# Namas Wind Farm, Northern Cape Province

Motivation for amendment of Environmental  
Authorisation

DEA Ref.: 14/12/16/3/3/1/1971

October 2019

**Figure 9.1:** Amended Namas Wind Farm layout overlain with environmental sensitivities, including updated bat sensitivity buffers (A3 Map included in Appendix I)

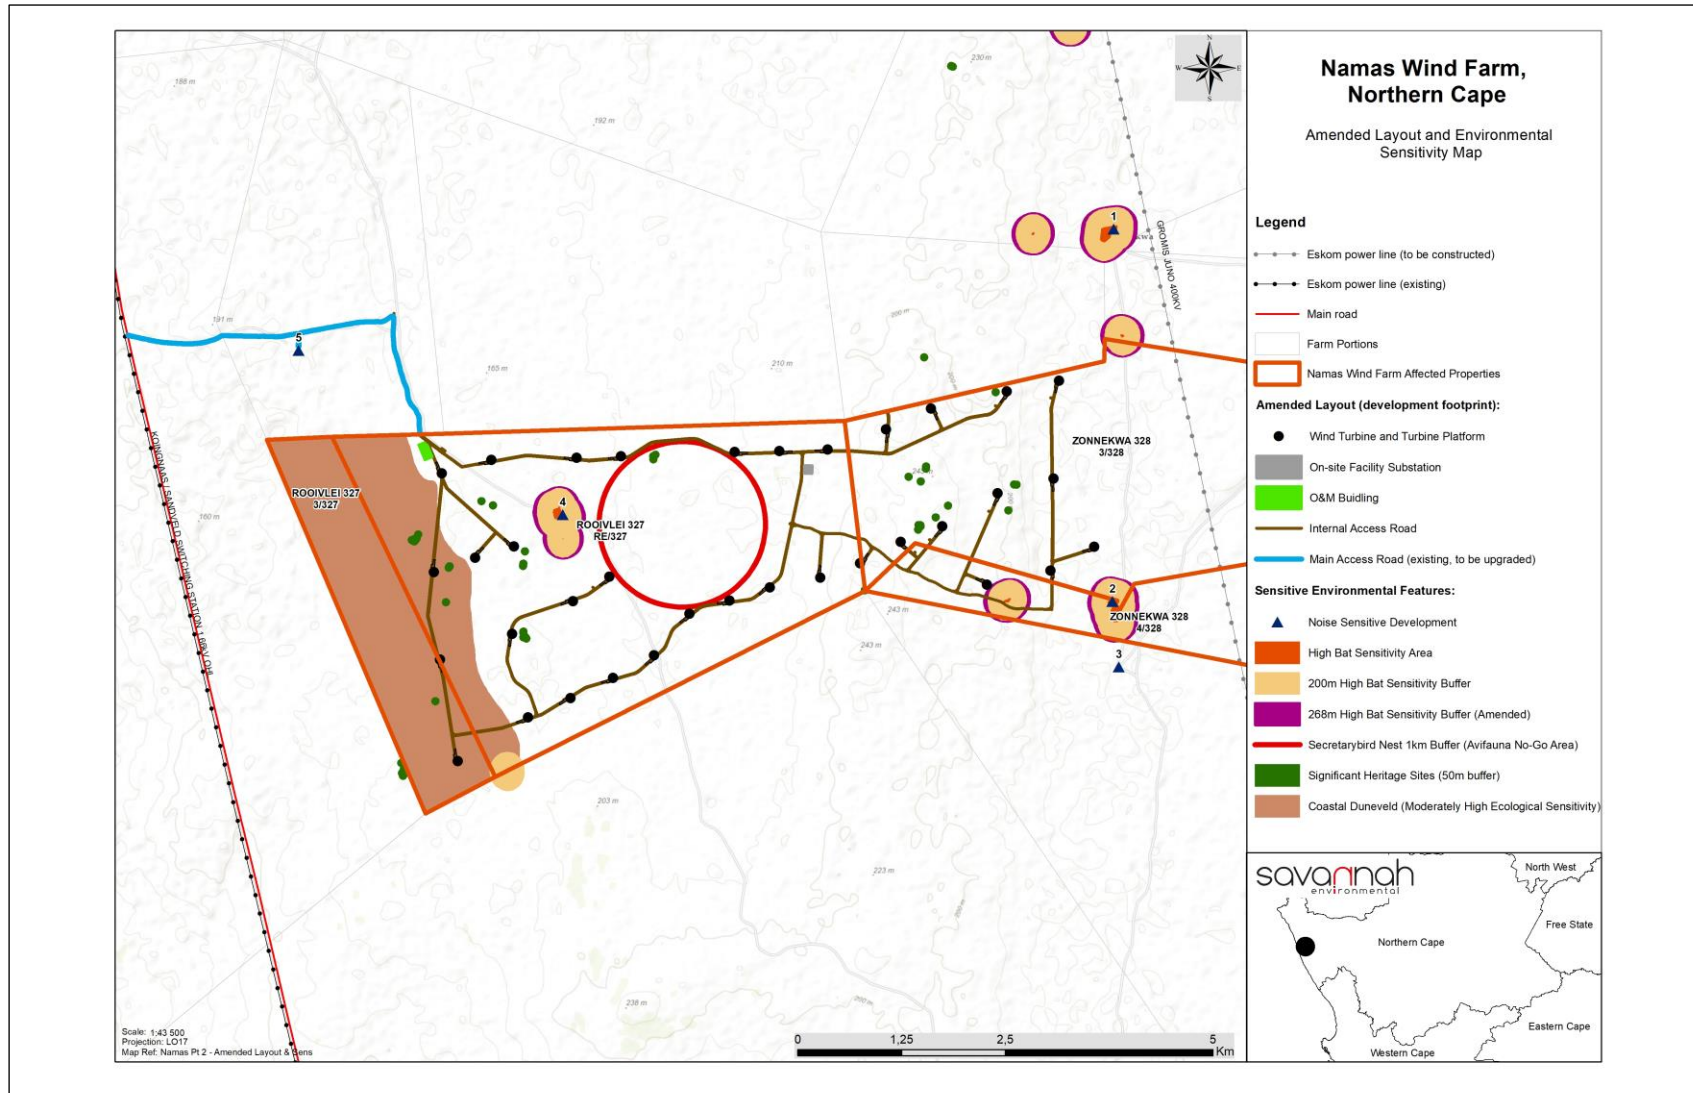
The requested amendments of the turbine specifications and number, as well as the layout will result in an optimisation of the layout assessed within the BA and the avoidance of sensitive areas. It must be noted that this amended layout is submitted to DEFF for review and approval in accordance with Condition 13 of the EA.
